Transition time in DR transmitters

Supporting comments R2-195 and R2-200 — 8 ps to 10 ps

IEEE P802.3dj D3.2, 2nd SA recirculation ballot

Bill Simms, Piers Dawe, NVIDIA

The straw poll record

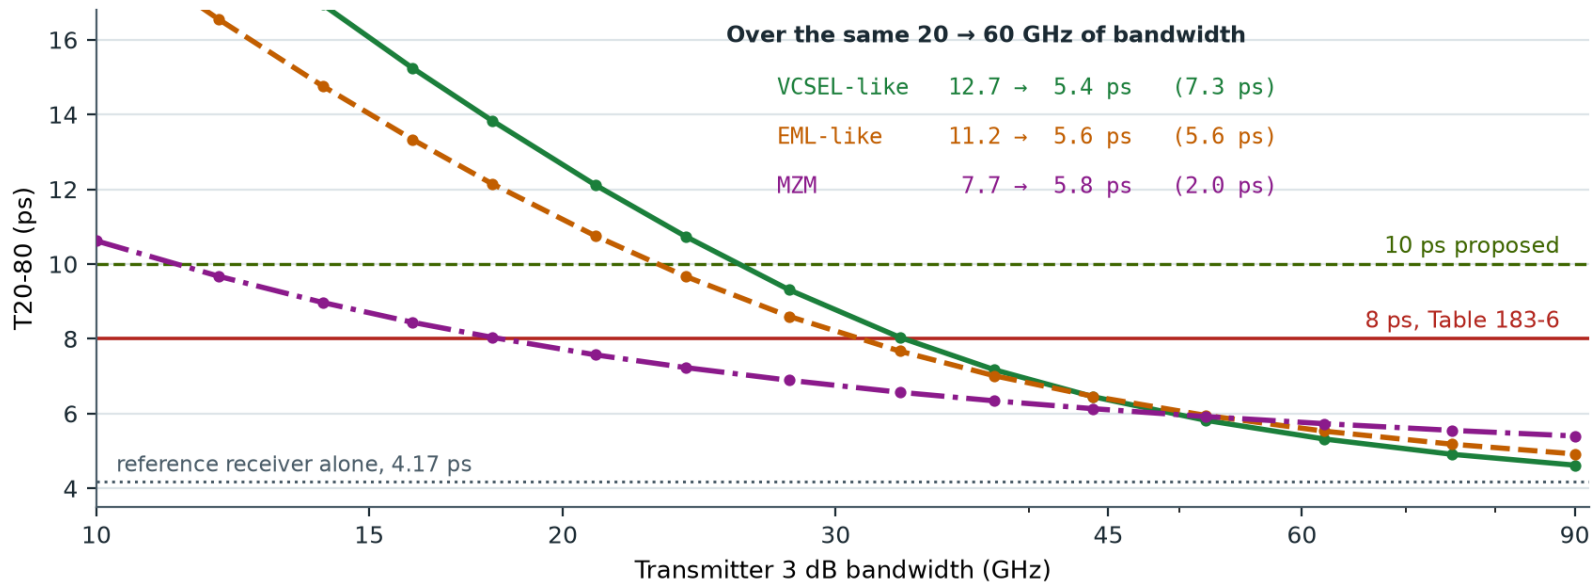
- **The record is presented in full because it does not favor this proposal.** In O-6, more voters wanted the limit tighter, 12, than looser, 3.
- **10 ps was never on the ballot.** O-5 and O-6 offered no change, 7.2 ps, or 12 ps. **O-7 offered no loosening option at all** — only 8 ps or 7.2 ps — so for Clauses 182 and 183 the room was never asked whether the limit should be relaxed.
- **And the comparison that matters was out of scope throughout.** 800GBASE-LR4's 13 ps was in none of the three polls, so the inconsistency this contribution raises has not yet been put to the task force.

Transition time in UI, which removes the line rate

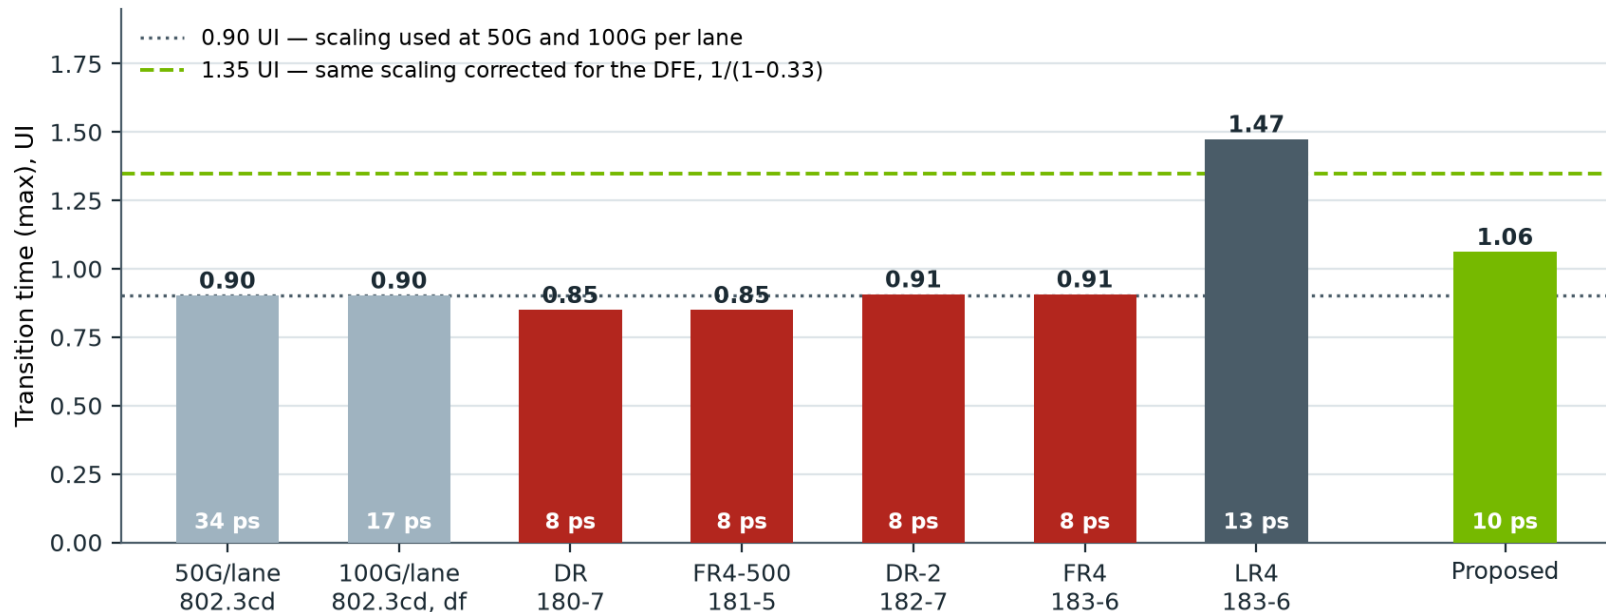
- **Scaled on UI, the draft's 8 ps is tighter than any shipped generation.** 0.85 UI at 106.25 GBd and 0.91 UI at 113.4375 GBd, against the 0.90 UI used at 50G and 100G per lane.
- **Corrected for the reference equalizer D3.2 actually specifies, that scaling gives 1.35 UI.** Only 800GBASE-LR4, at 1.47 UI, is above it.
- **10 ps is 1.06 UI and 1.13 UI at the two rates** — above the old scaling, still below the DFE-corrected line, and at least 23% tighter than 800GBASE-LR4.
